RESPONSE TO COMMENTS

dEIS Review and Comments
DEC 8-3436-00033/00001 MLR 80823
Frontier Stone LLC. Proposed Shelby Quarry
Shelby (T) Orleans County

September 11, 2012

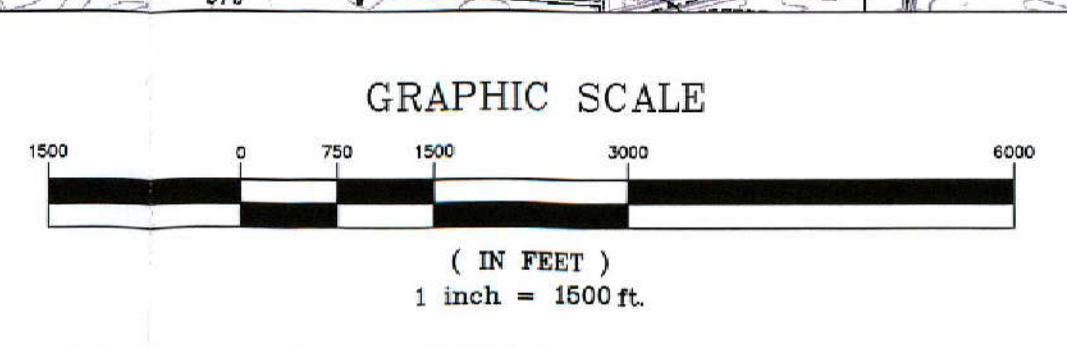
Comment 5: Impacts on the Iroquois Nation Wildlife Refuge (ENWR) have not been adequately addressed and additional information/clarification is required. The noise and vibration limit boundaries on Plate #3 of the dEIS, Proposed Quarry Impact, need to be revised. The noise boundary limit does not take into account air blast which could approach 134 dB. Also, the human perception vibration limit should be assessed at 0.05 in/sec. Applicable narrative discussions should be updated to evaluate these changes.

Comment 14: The analysis of projected noise shown on Plate 3 only seems to address the noise generated by mining noises other than blasting. The plate should include the area of influence from blasting noise in addition to the other quarry noise sources. While it may be true that the total impact of blasting will only be 3 minutes per year, an analysis should still be done to determine the area of influence from this activity, and there should be a discussion of the habitat types and species of wildlife that may be affected by the noise generated by the blasting. The impacts to recreation in the area of influence from blasting noise should also be discussed.

Response: A line has been added to Plate #3 which delineates the effect of blasting noise on the surrounding environment.

■ REFUGE AREAS IMPACTED BY HUMAN ACTIVITY SUCH AS TRAFFIC, FARMING AND RESIDENTIAL ACTIVITY. PROJECTED dBA LEVEL >50
■ PROJECTED dBA LEVEL >60

GEOLOGIC CROSS SECTION LOCATIONS

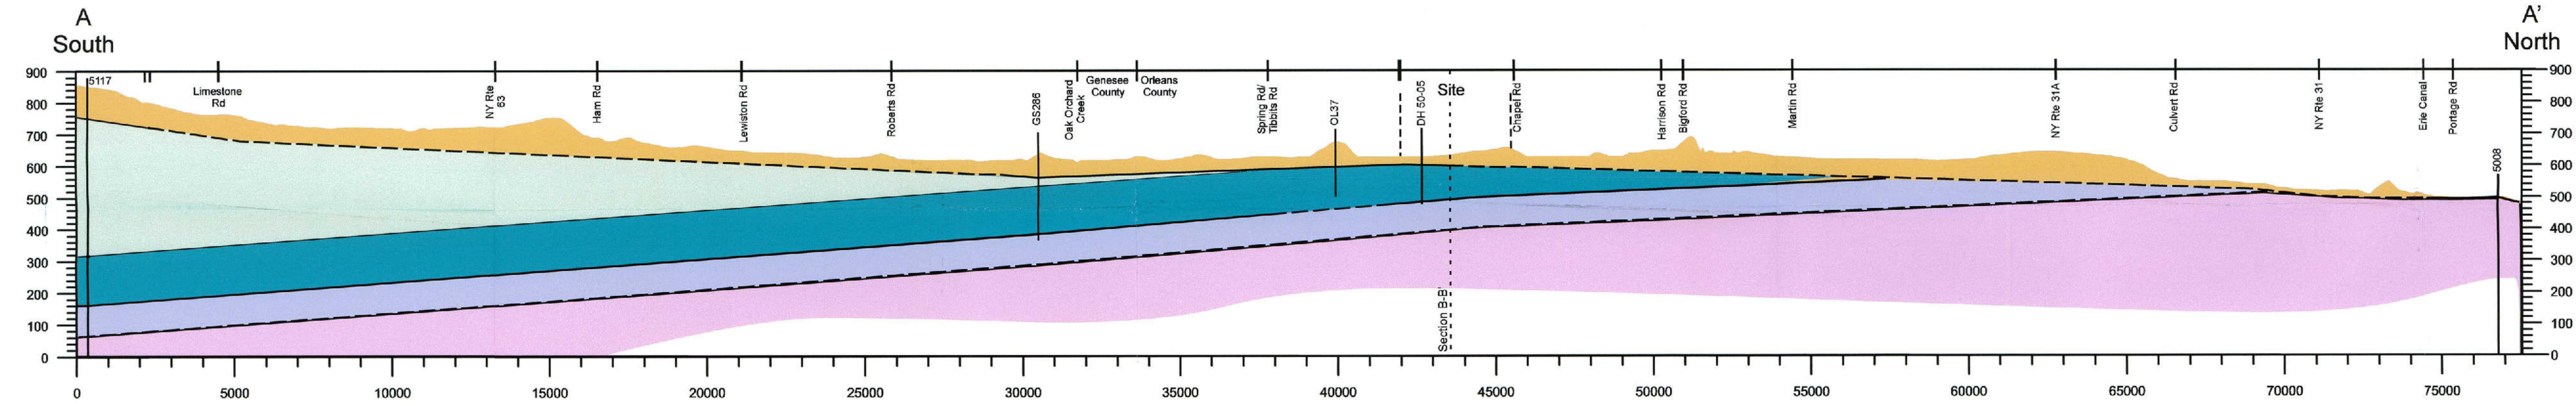
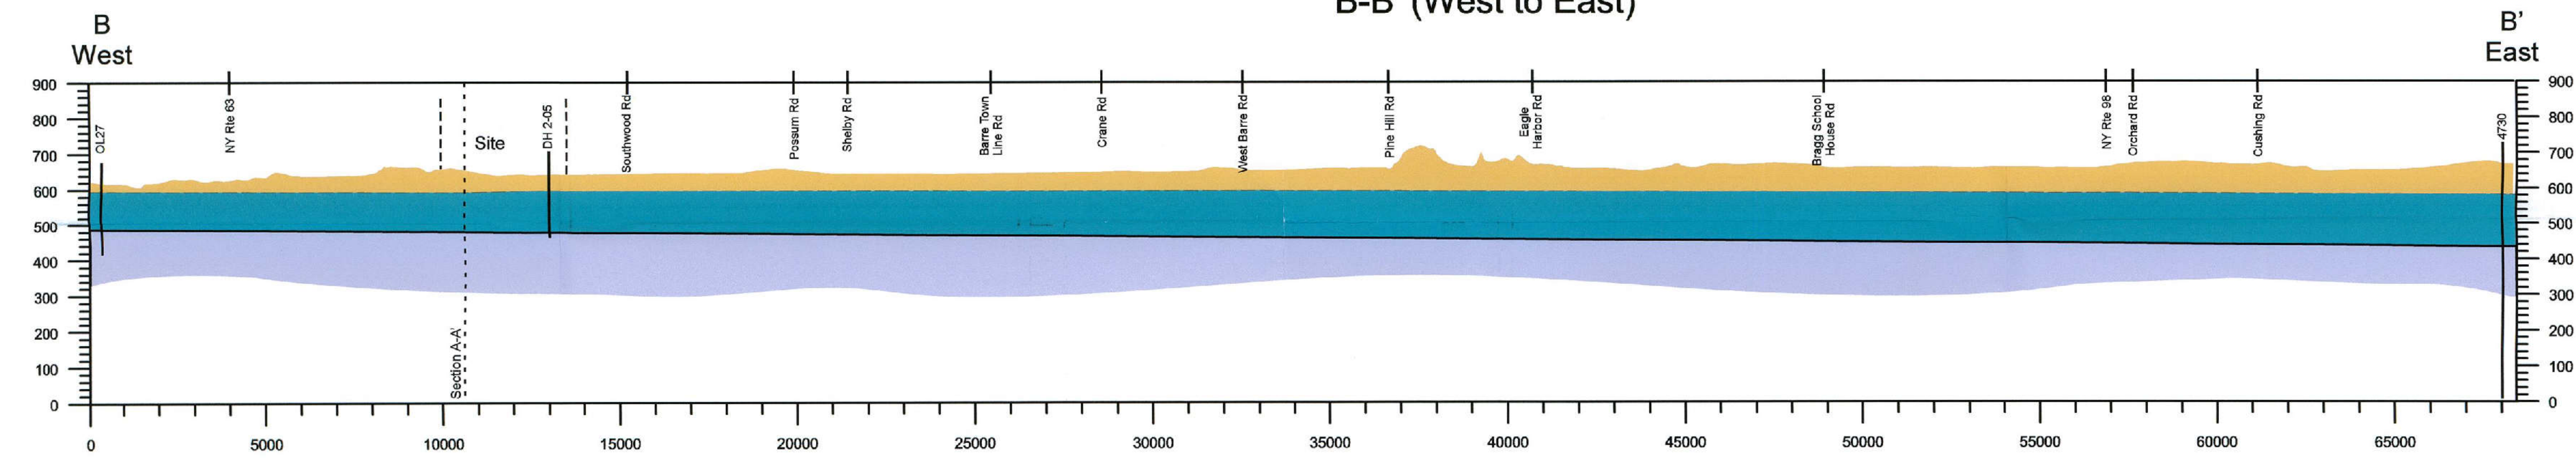
Comment 10: It has been brought to the Department's attention that a potentially unique geologic feature exists within the IWWR that may be negatively impacted by drawdown caused by quarry dewatering. The USGS and Refuge staff have raised concerns over the Oak Orchard Acid Springs. These springs were discovered in the early 1800's and are the source of a unique bedrock groundwater discharge of water with a pH of approximately 2.0. An analysis must be provided to determine if the drawdown could potentially affect the acid springs and how they function. Additional information pertaining to these springs, as well as their location can be acquired from Refuge staff.

The north-south cross section shows that there are approximately 35 ft. of the Salina Group rock above the Lockport Group at the GS-286 well location. This projection from the cross section is consistent with the gamma log for GS-286 in the Kappel and Jennings (2012) publication that shows a similar thickness of shaly material in the upper part of a unit identified in the USGS report as the Guelph Formation. It is also consistent with the Bedrock Geology of New York State - Niagara Sheet, which indicates Oak Orchard Creek, near well GS-286, is underlain by Salina Group shale. The reassignment of the upper part of the rock to the Salina Group at GS-286 is also consistent with the observation that the USGS has an interpreted thickness of more than 170 ft. at GS-286 for the Lockport. This is thicker than the typical Lockport Group in the area.
